Brisbane Central Business District Bicycle User Group

Toowong to Indooroopilly Commuter Bikeway Corridor

Figure 1: Current and proposed Perrin Park bike routes

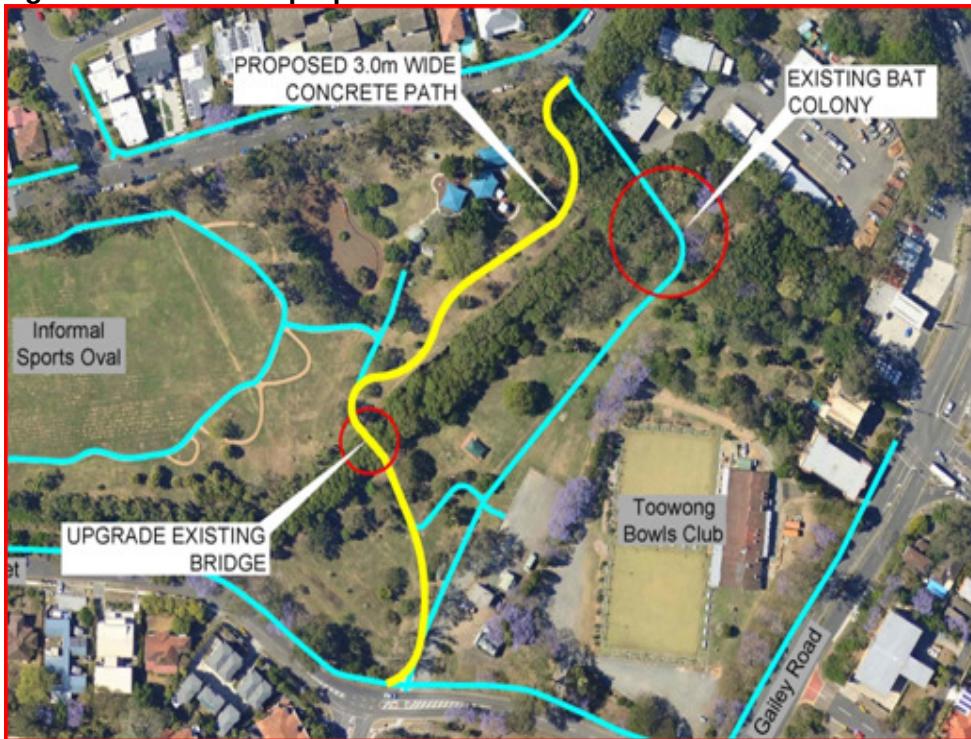
The route proposed through Perrin Park is likely to be significantly slower with more unnecessary bends than the current route as noted in Figure 1 on the following page. The proposed new path will run very close to the playground, introducing the potential for conflicts with young children running onto the path. On installation it is stated there will be no lighting, and there is no indication as to when this will ever be installed.

In contrast, the current route is well lit beside the existing dog park, and at least offers some passive surveillance from the bowls club, and the SES depot. Though this is far less than ideal, it is significantly better than the proposal. It is unclear what is wrong with the existing path through Perrin Park.

The "existing bat colony" marked in this figure seems mostly to have relocated very recently and is now significantly smaller than when the plans would have been drawn up. It used to extend significantly further than indicated and people riding bikes on the proposed path would have been affected by bats to the same extent as those on the current path. Also, while the current path does flood in heavy rains the 'new & improved' path is actually lower (near the bridge) than the existing path so it is likely to flood more frequently and be impassable.
